RE: Waterford Square 2nd Filing

WATERFORD SQUARE
2ND FILING
OF

UDC-16-00539-01
Final Plat/Replat

REVIEWER COMMENTS

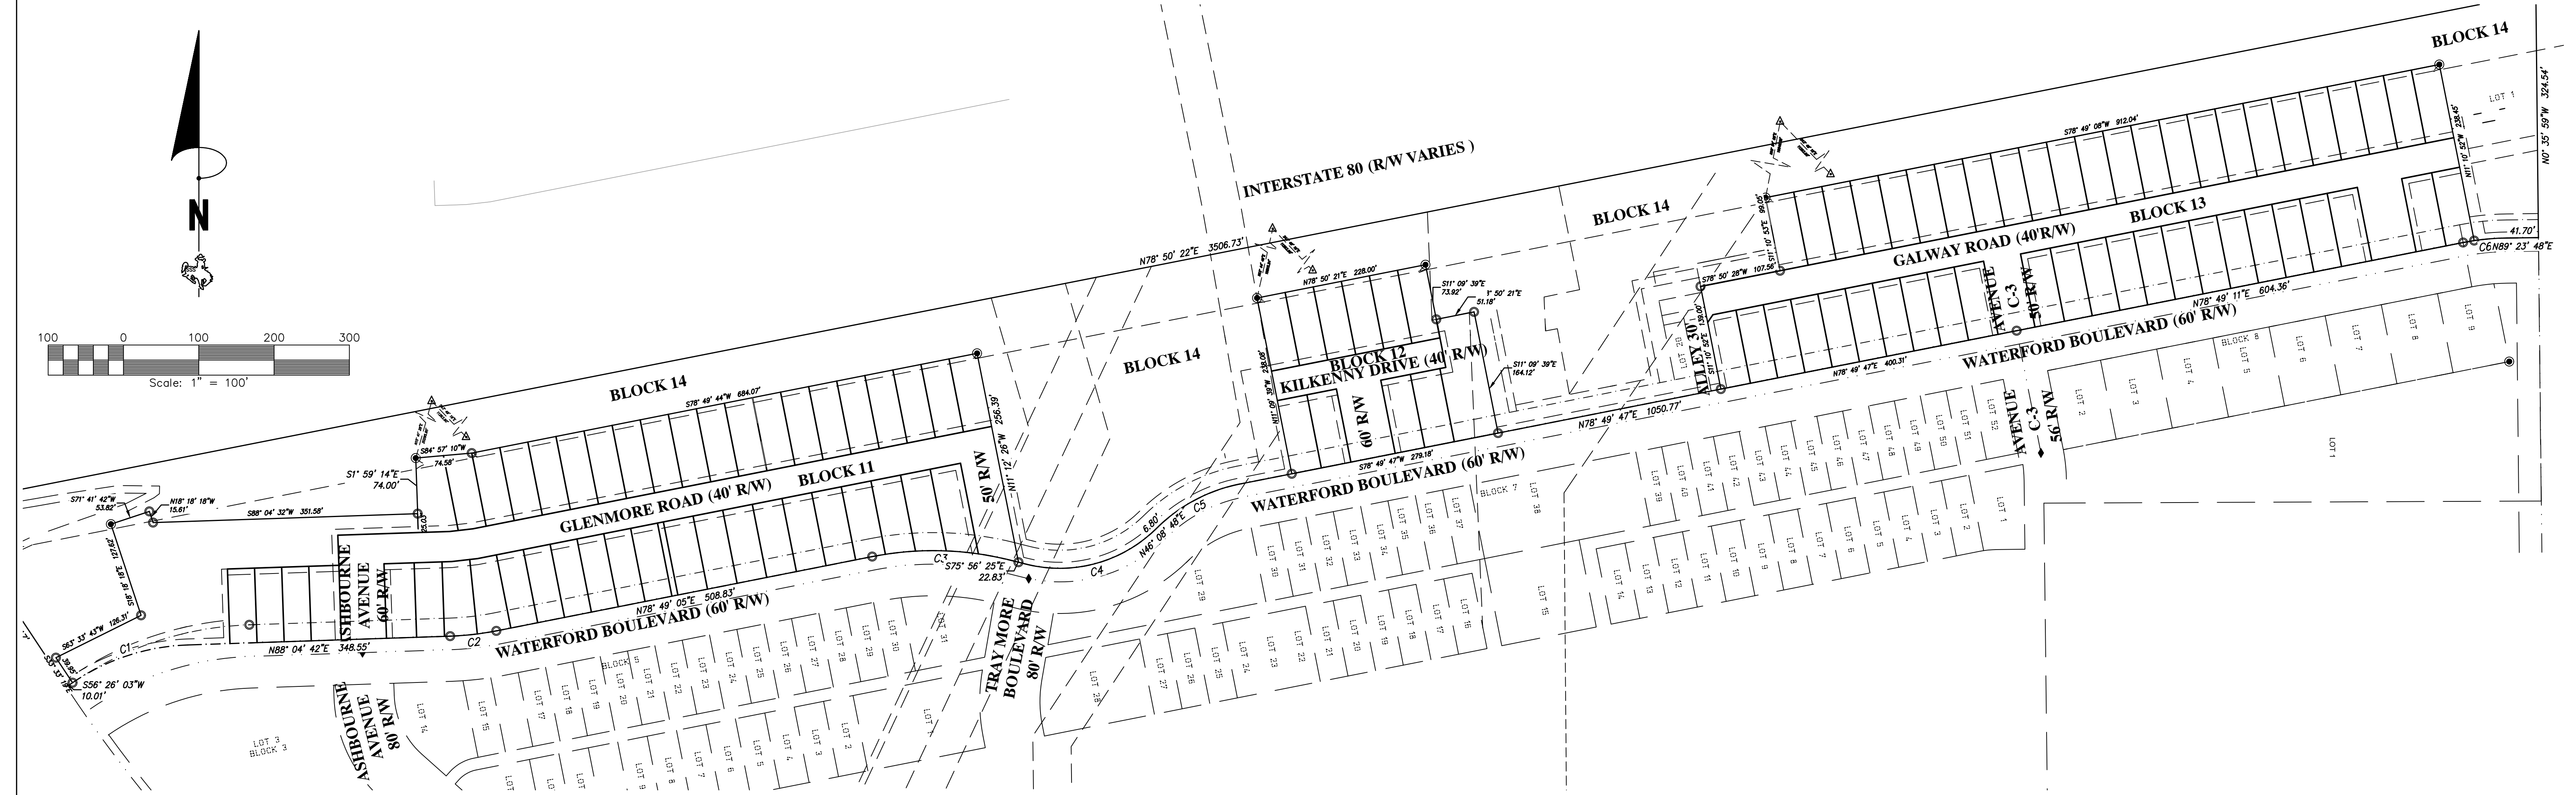
1. Name all small north-south connector streets.
2. Include the entire right-of-way of Waterford Blvd in the plat (to the south right-of-way line).
3. Add a drainage easement over the detention pond.

4. Include Lot 1, Block 6 of Waterford Square and add the City of Cheyenne as an owner on the plat.
5. Remove General Note 4, as it does not apply to this plat.

6. Replat the portion of Traymore Boulevard south of Waterford to align with the intersection created by this plat.
7. Adjust the lot line between Lots 2 and 3, Block 11 to allow the proposed duplex to meet setbacks.

8. Work with the City Parks department to provide all park facilities required by the MOU.
9. Re-align, remove, or adjust the utility easements to reflect the current plat's dedication of Right-of-way.

10. Adjust the technical aspects of the plat map to meet the recommendations of the City surveyor.
11. Provide a revised map to City (prior to submitting for recording) for agency review - to meet the request of the County Clerk and to allow review of the fulfillment of other map conditions.
